Re: Snow Removal Equipment Building
Brookings Regional Airport
Brookings, South Dakota
AIP #3-46-0005-041/042-2025
Helms #A-10258

ADDENDUM NUMBER 2

Addendum No. ME-2
To Mechanical Plans and Specifications:
Brookings Airport New SRE Building
Brookings, South Dakota

Addendum Dated: July 28, 2026

M1/E1

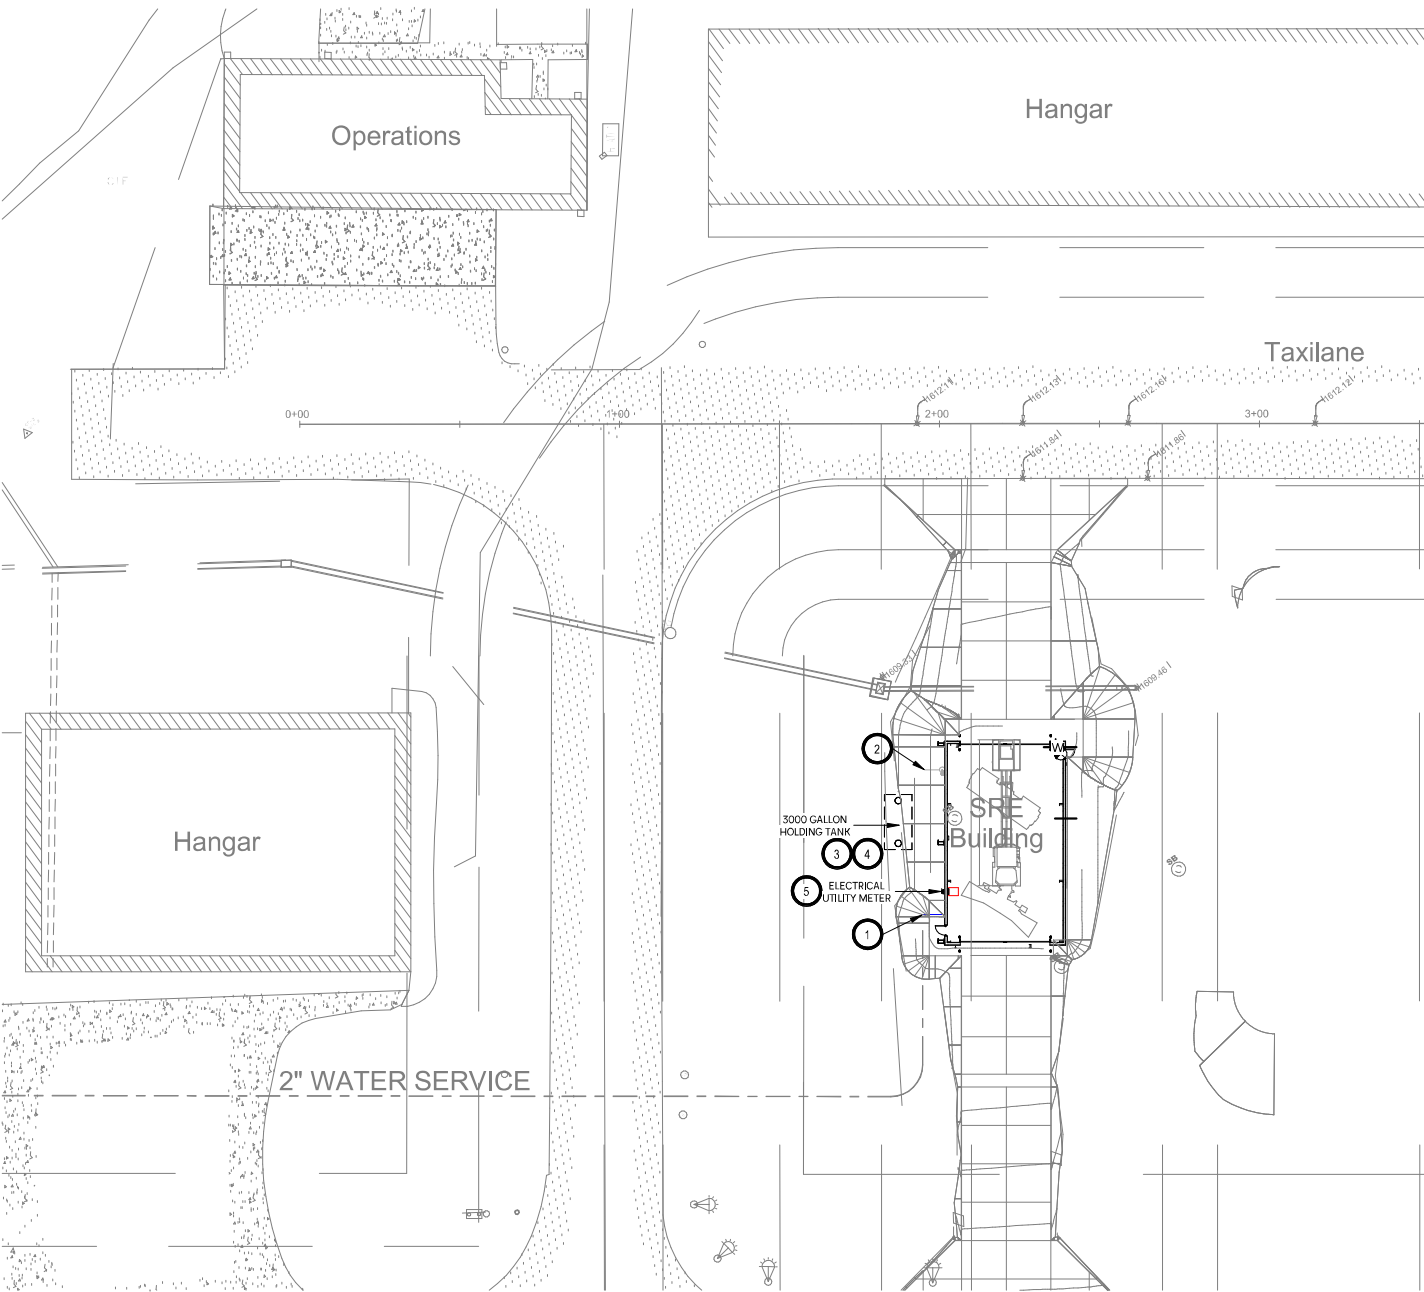
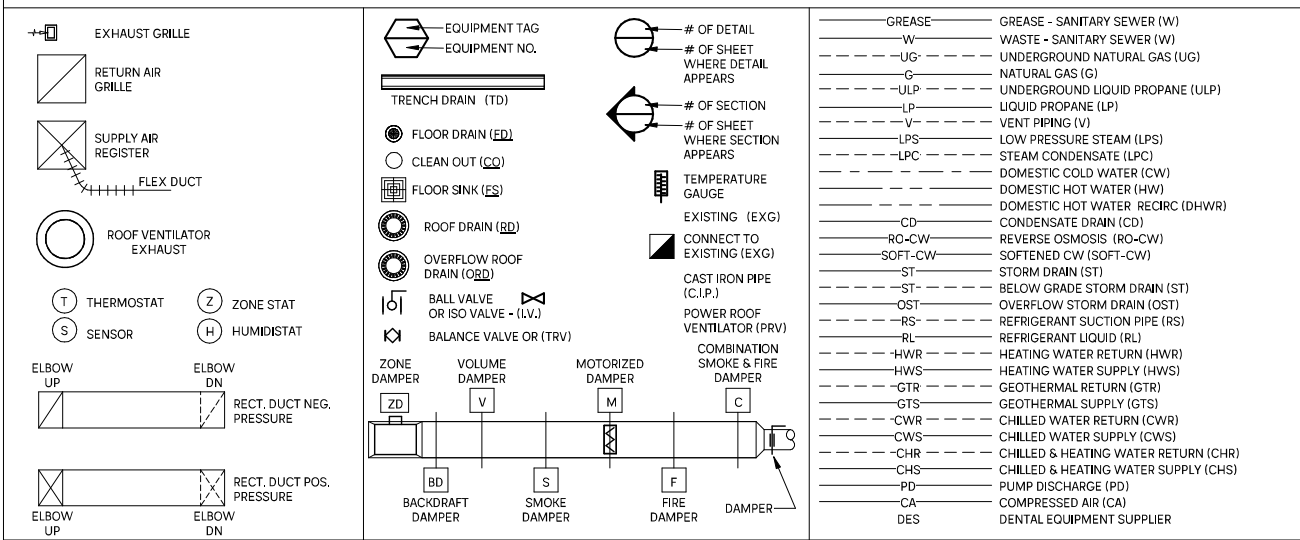
1. Sheet M1 – Revised keynote 1 to clarify base bid/alternate scope of water service.
2. Sheet M2
 - a. Revised keynote 2 to clarify base bid/alternate scope of water service.
 - b. Added Indirect Condensate Piping Diagram and associated waste/vent piping for boiler condensate.
 - c. Revised Water Header Piping Diagram to clarify Base Bid/Alternate water service work

- BY ALTERNATE - CONNECT NEW 2" DOMESTIC WATER SERVICE TO NEW 2" DOMESTIC WATER SERVICE INSTALLED BY SITE UTILITY CONTRACTOR AT THIS LOCATION 5' OUTSIDE THE BUILDING. FURNISH AND INSTALL THRUST BLOCKS AND/OR TIE-RODS IN ACCORDANCE WITH THE LOCAL WATER DEPARTMENT STANDARDS AND REGULATIONS. VERIFY EXACT LOCATION, AND INVERT. BASE BID TO INCLUDE SERVICE STUBBED OUT 5' FROM BUILDING WITH CAP FOR FUTURE, AND SERVICE INTO BUILDING WITH VALVE AND CAP FOR FUTURE. SEE WATER HEADER PIPING DIAGRAM.
